RE: City of Dumas WWTF Inspection

AFIN: 21-00045 Permit No.: AR0033987

OFFICE OF WATER QUALITY INSPECTION REPORT

AFIN: **21-00045** | PERMIT #: **AR0033987** | DATE: **8/2/2023**

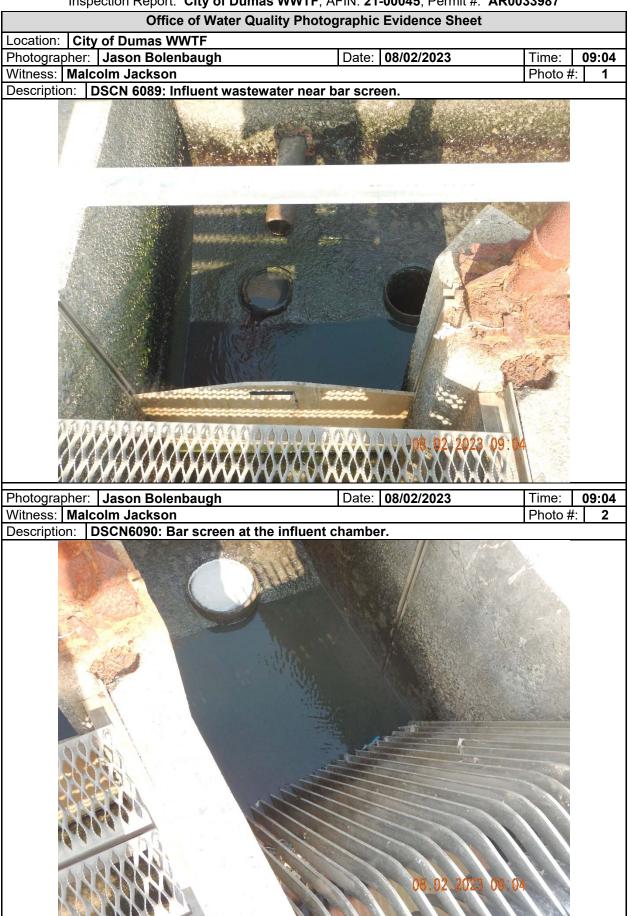
- 3. A flow measurement verification was conducted in which the maximum deviation was greater than ± 10% from true discharge (see flow calculation sheet below). The error may be due to the primary staff gauge in the Parshall flume not being affixed to the flume wall appropriately. Please affix the staff gauge properly to the flume wall and maintain the gauge so proper measurements can be taken.

-				
% Error =	0.55	- 0.48	883	X 100	
70 E1101 -	0	.4883		X 100	
	0047				
% Error =	.0617	X 100			
	0.4883				
% Error =	0.1263	X 100			
70 E1101 -	0.1200	7 100			
% Error =	12.63	%

Comments: Per Part III, Section C.2 (Flow Measurement), the device selected shall be capable of measuring flows with a maximum deviation of less than ± 10% from true discharge rates. I believe the flow measuring devices can accomplish this however, the staff gauge on the Parshall Flume must be affixed to the flume wall appropriately and be clean enough to record a primary flow measurement.

DMR Calculation Check

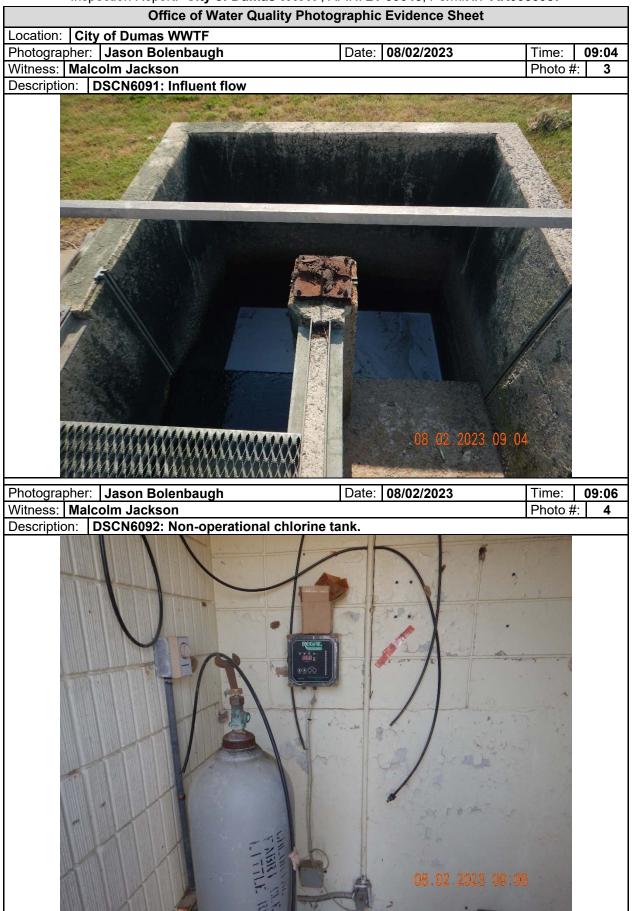
If calculated value does not equal reported value, explain: Small discrepancy in the mass loading calculation. The permittee may need to verify the recorded flow information in the calculation.
